ADDENDUM # 4

Project	TA Blakelock High School Renovations	Project No.	2215-C
Location	1160 Rebecca Street, Oakville, ON	Date of Issue	2025 05 02
Owner	Halton District School Board	File	2215/7.1.3

This Addendum forms part of the Contract Documents and amends the original Drawings and Specifications, dated 2025 04 17, and all preceding Addenda, as noted below.

HIGH ROOF FRAMING PLAN
SCALE: 1:100

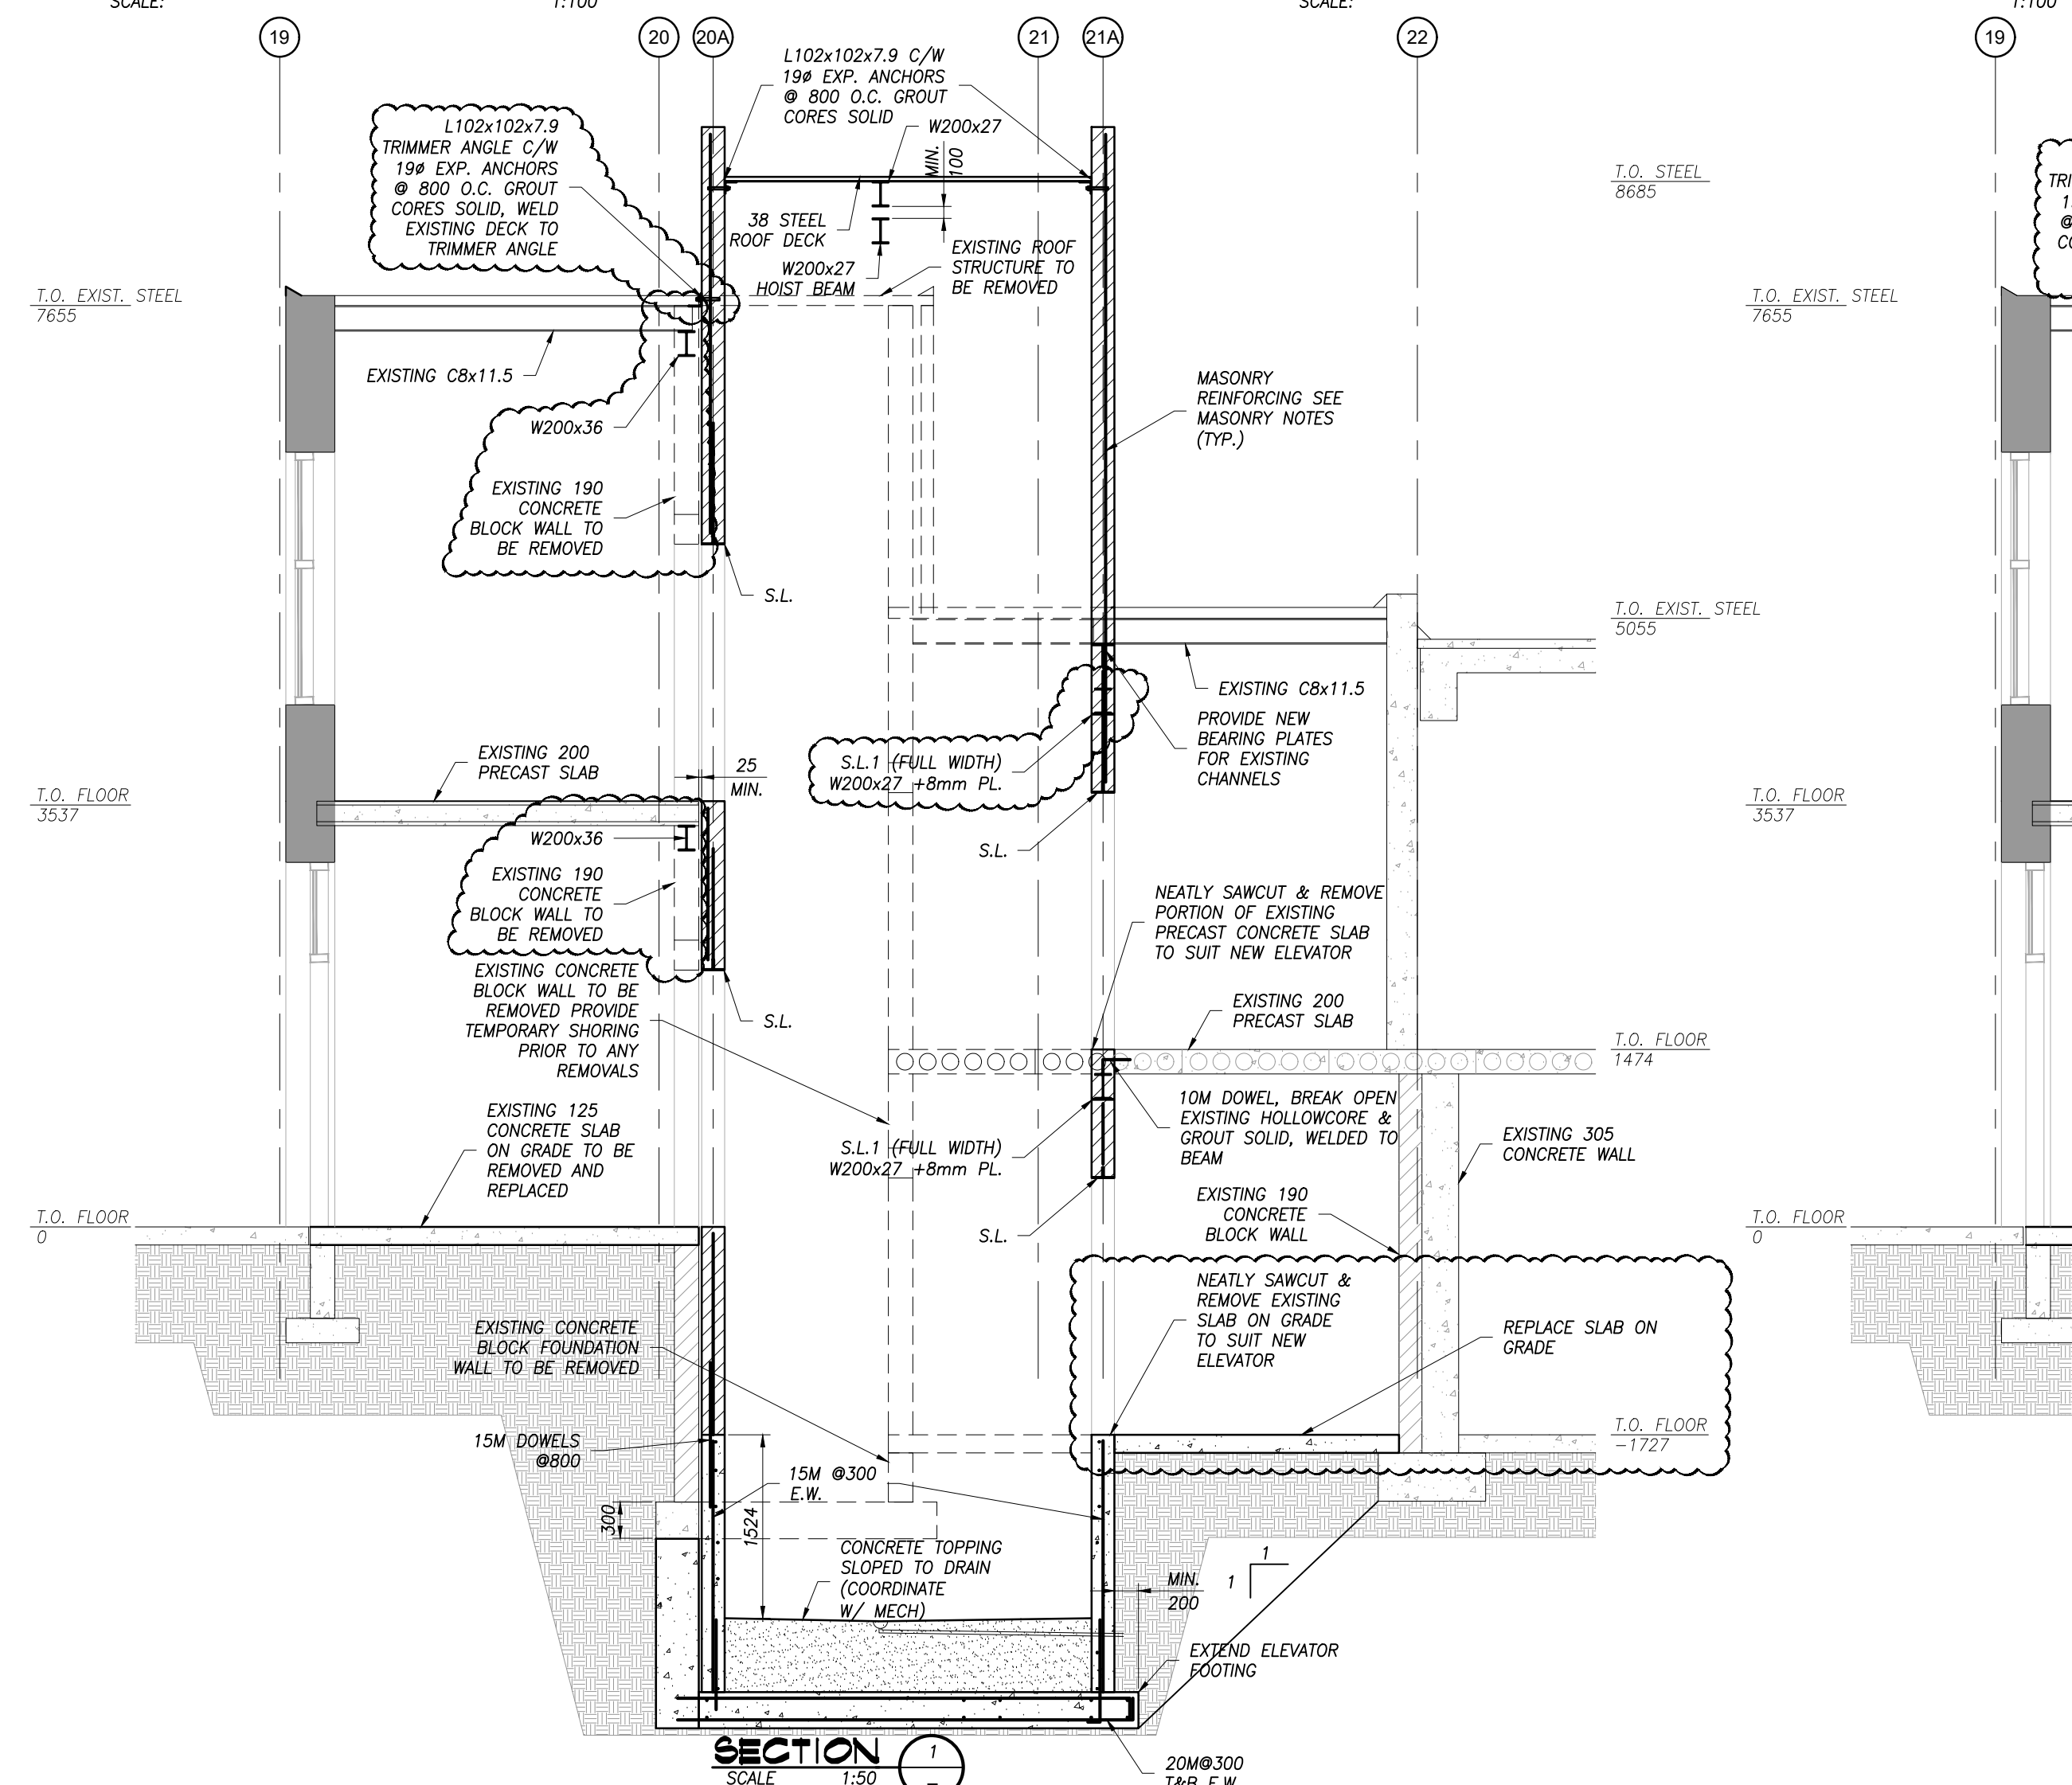
- A. Drawing S000:
 - a. General Steel Deck notes added to the drawing.
- B. Drawing S100:
 - a. Extent of grouting existing foundation wall for new column clarified.
- C. Drawing S200:
 - a. West Elevator framing updated to match architectural sections.
- D. Drawing S300:
 - a. East Elevator framing updated to match architectural sections.
